# SUPPLEMENTAL REPORT: Analysis and Review REVISED North Woods Master Plan Subdivision

Prepared for the  
Residents of Henry Case Way

Prepared by  
Ashley V. Sweet  
Professional Planning and Land Use Consultant  
July 10, 2020

Site Plan by Fontaine Land Surveying, LLC

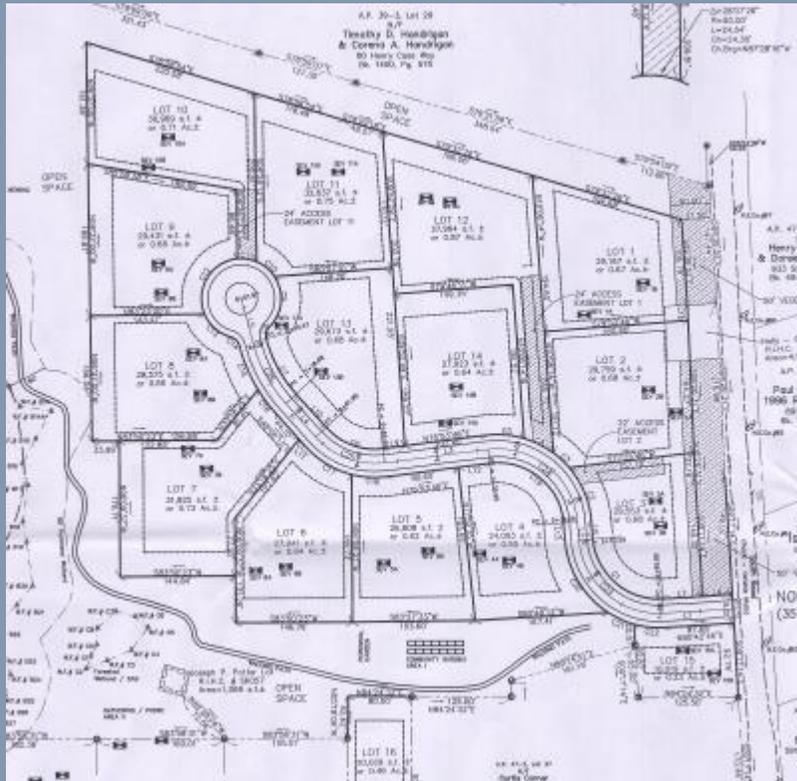
- Northern boundary of Lot 10 increased to 60' vegetated buffer. A portion of the buffer is within Lot 10. How will this be maintained as a vegetated buffer? There is no viable enforcement mechanism if the buffer is partially on private property. The Town will have a difficult time enforcing any provisions of the buffer on private property.

- Northern boundary of Lot 1 has increased vegetated buffer to 60'. A portion of the buffer is within Lot 1. How will this be maintained as a vegetated buffer? There is no viable enforcement mechanism if the buffer is partially on private property. The Town will have a difficult time enforcing any provisions of the buffer on private property.

- Northern boundaries of Lots 11 and 12 remain at 50' buffer. This location was presented as an area that requires additional buffering to protect the abutting neighborhood on Henry Case Way. It seems counterintuitive to not increase the buffer width in this area.

- The words "Community Bus Stop" were added to the front affordable lot, which no longer has a lot number associated with it. Was this removed as an affordable house lot/location? Lot 2 (fronting along South Road) is now labeled as an "LMI Lot"

- Portions of the buffer are labeled "60' Vegetated Buffer" while the central portion is labeled as "50' Open Space Buffer". What is the difference besides the width increase of 10' and why is it being presented this way? Monumenting and maintaining a buffer is difficult enough without varying widths and nomenclature.

- The eastern property boundary is similarly labeled with alternating widths of 70' and 80' with portions of the open space or buffer area on private property.

- The site plans use the same cross hatching for both access easements and those areas alternately labeled "vegetated buffer" and "open space buffer". This is confusing and makes no distinction between an access easement and a buffer. Is the access easement area being counted in the overall open space calculations?
